Project: LAND TO THE EAST OF THE FORMER TAMWORTH GOLF COURSE, TAMWORTH

D. Stage 1 Road Safety Audit & Designers Response

STAGE 1 ROAD SAFETY AUDIT

Road Safety Audit Response Report

10.0 PROBLEM LOCATION PLAN

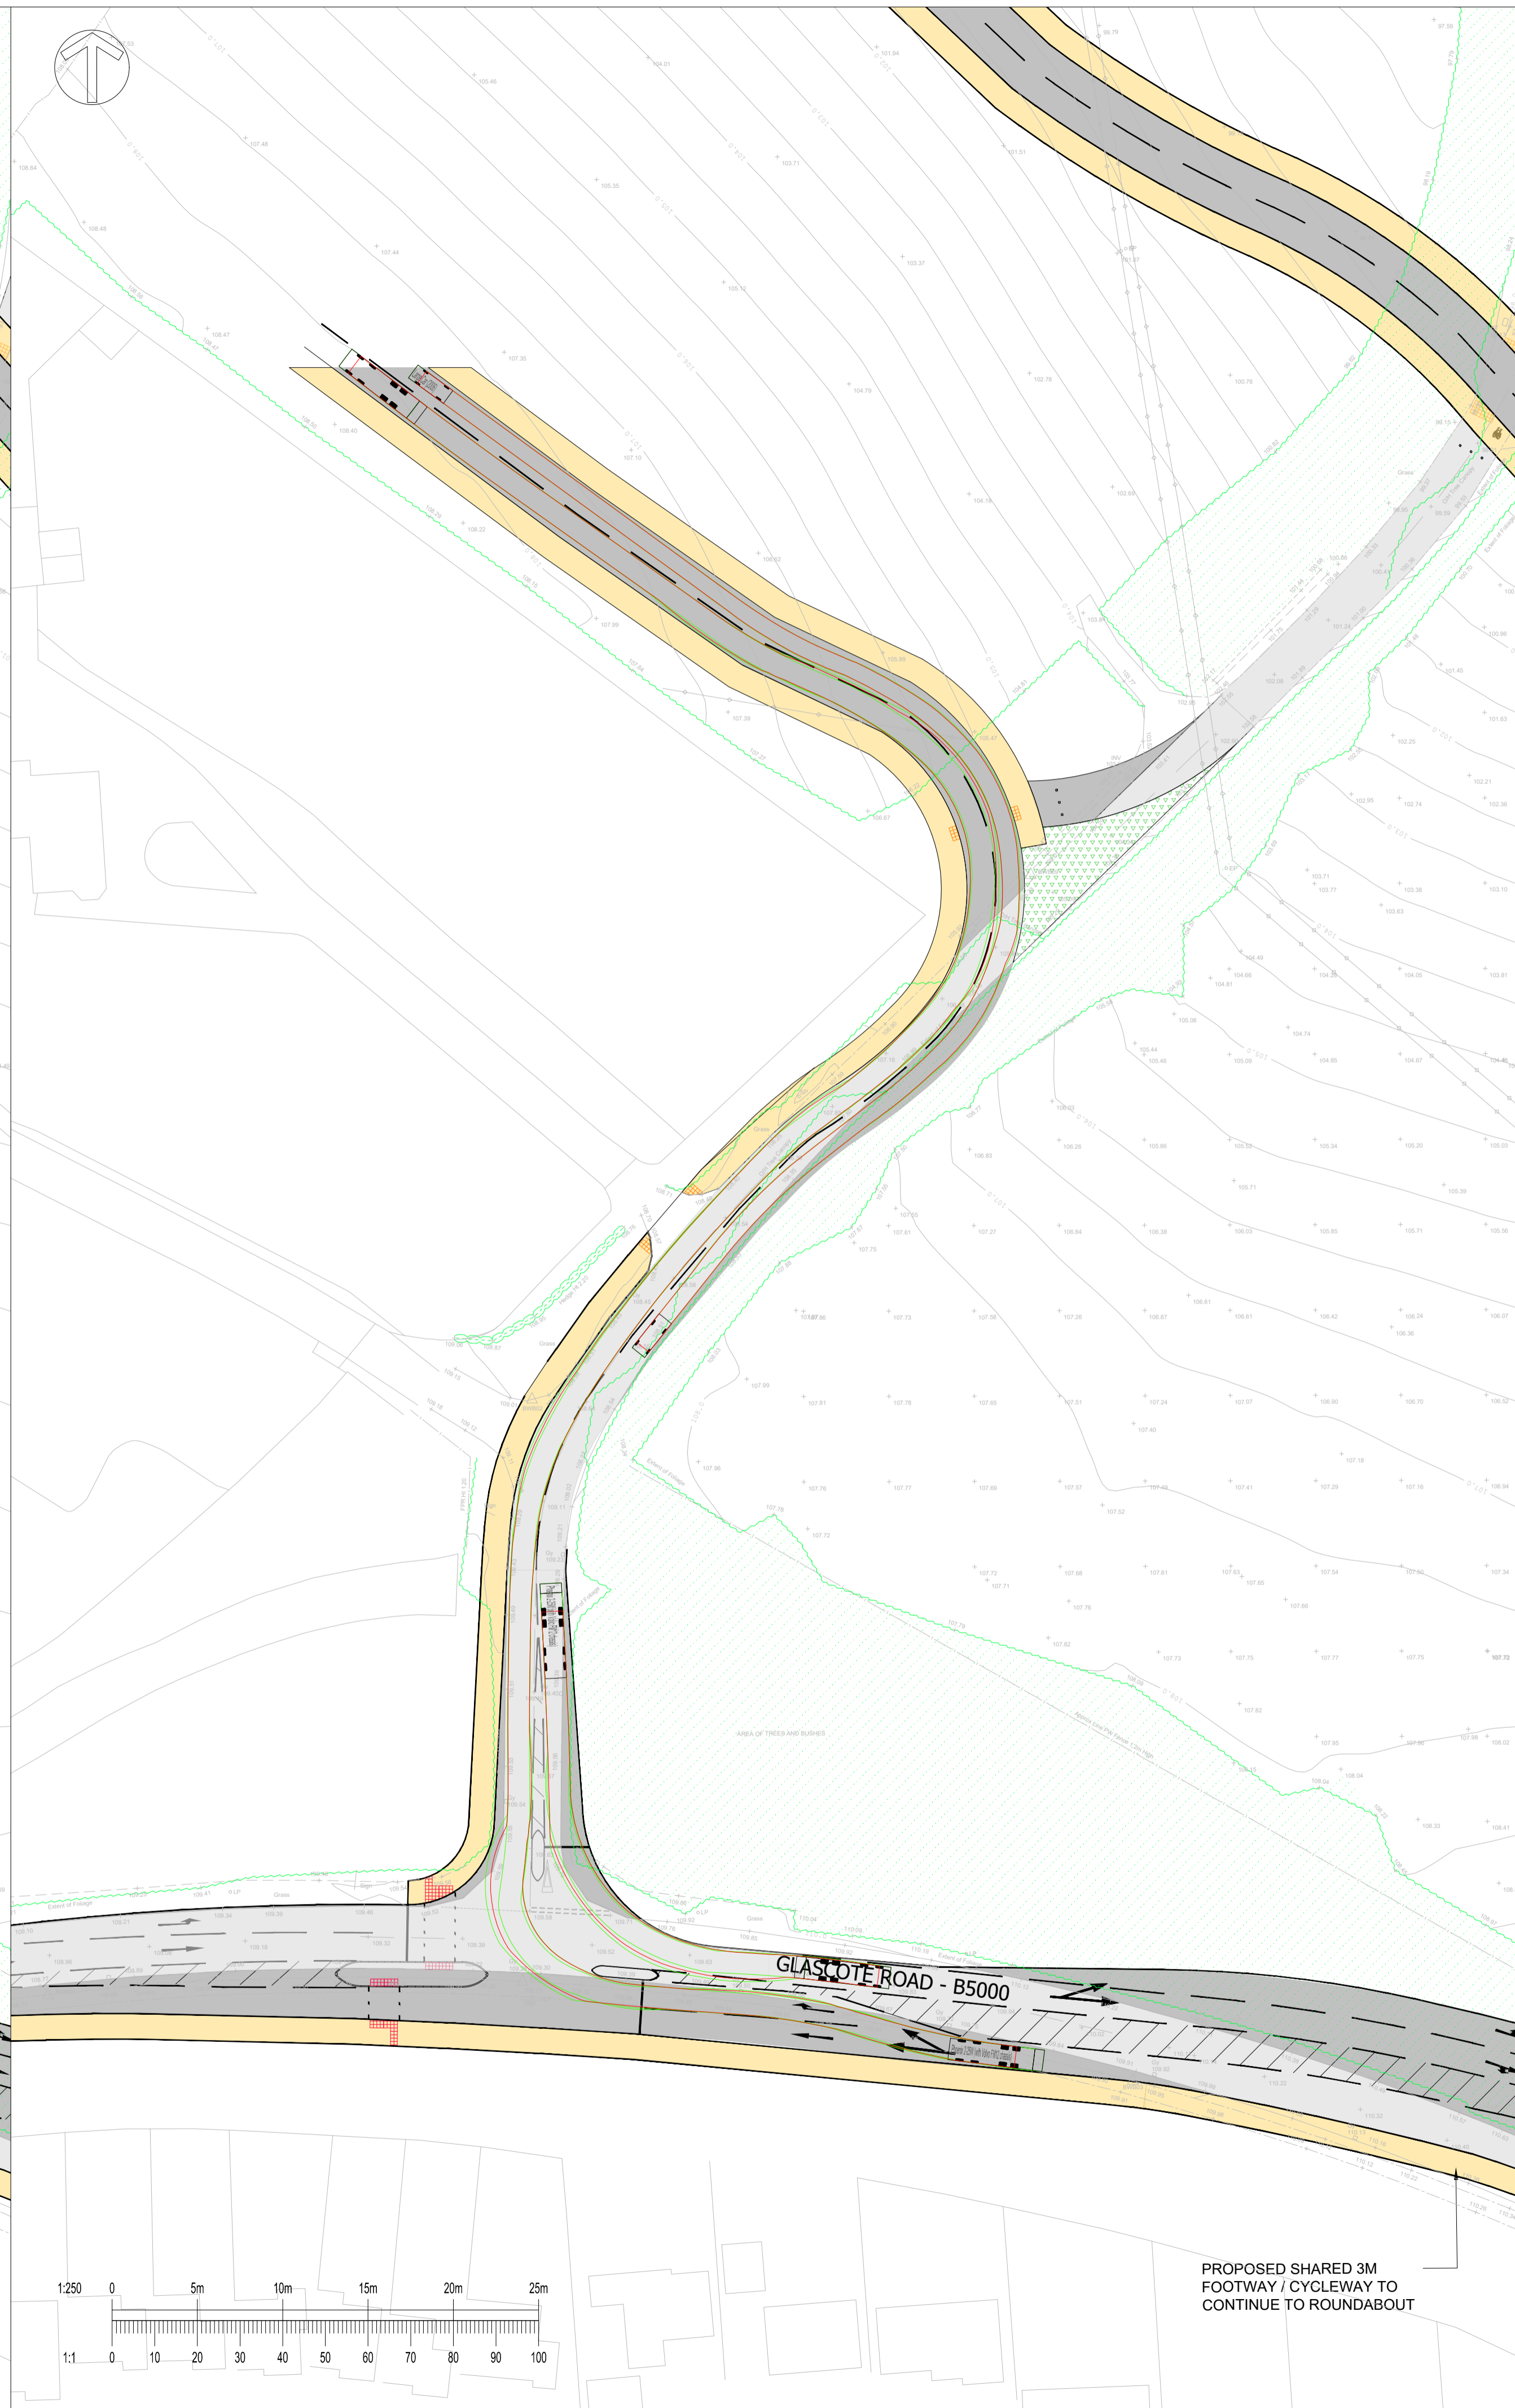
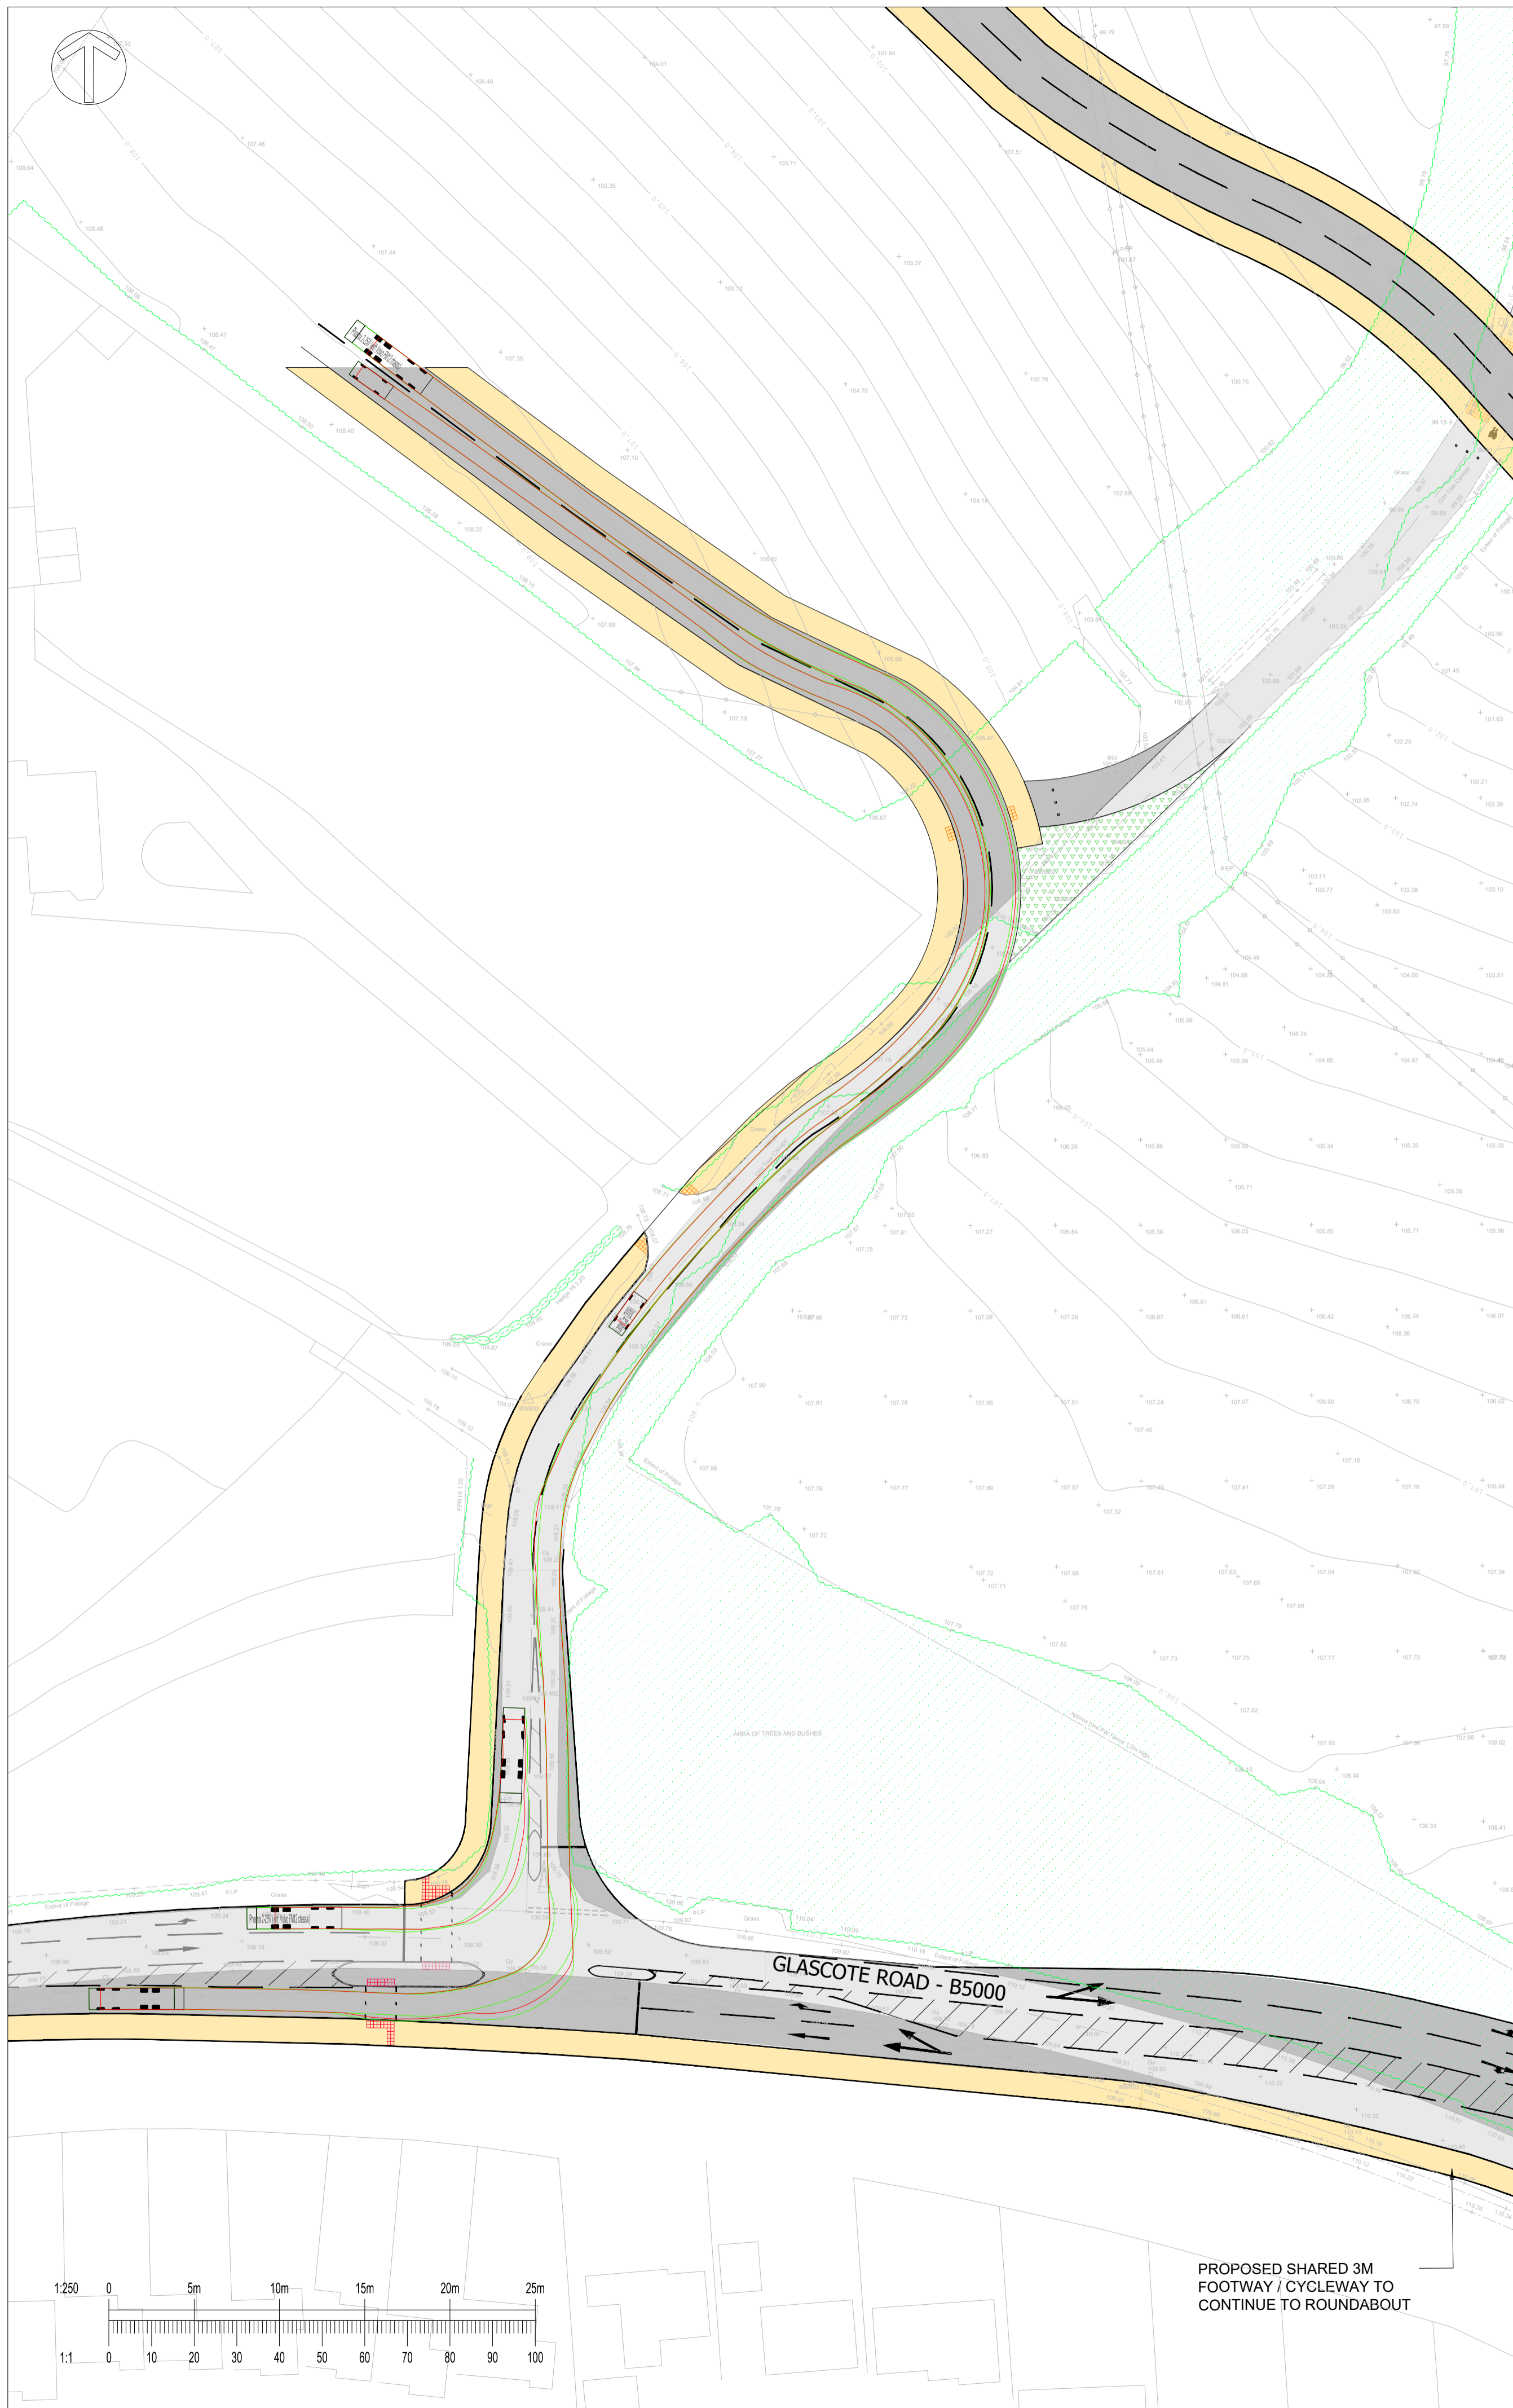
7.1 Problem

The approach to the junction from the south-east on Tamworth Road is on the brow of a hill. This could act to reduce forward visibility to the roundabout for drivers approaching from this direction. If drivers do not see and are not aware of the roundabout, then a variety of types of collisions could occur as drivers do not slow down in time to cede priority thereby running the risk of overshooting the junction.

7.2 Problem

New bus stops are proposed in both directions immediately off the roundabout on the south eastern arm. Drivers leaving the roundabout may not be expecting a bus to stop such a short distance off the roundabout, which could lead to rear shunt type collisions. A stationary bus at the bus stop could also lead to following drivers overtaking the bus, which given the limited visibility of vehicles leaving the roundabout could lead to head on type collisions.

7.3 Problem

No signal layout has been provided, nor the achievable forward visibility on the approach to the signals. If insufficient it could lead to rear shunt type collisions as vehicles approach the rear of a queue.

7.4 Problem

No swept path analysis has been provided to the Audit team. The left turn out of Robey's Lane appears to be tight past the central island. If insufficient it could lead to larger vehicles striking the island and in turn the signal equipment, guard railing or pedestrians on the island.

7.5 Problem

The proposed closure of a section of Robey's Lane close to Priory Park results in the creation of a sharp left bend into the development site / field to the west. If a driver unfamiliar with the changes were to proceed down Robey's Lane at speed, there is a risk that they could attempt to go straight on along the old alignment of the road resulting in them overshooting the bend and leaving the carriageway.

It is recommended that there is appropriate forward visibility for drivers approaching the roundabout.

It is recommended that the bus stops are relocated further from the roundabout

It is recommended that there is appropriate forward visibility for drivers approaching the junction.

It is recommended that vehicle swept path analysis is carried out to ensure vehicles can make all manoeuvres at the proposed junction.

It is recommended that measures be included within the design to ensure the potential hazard posed by the road realignment is made obvious to all drivers and mitigated.
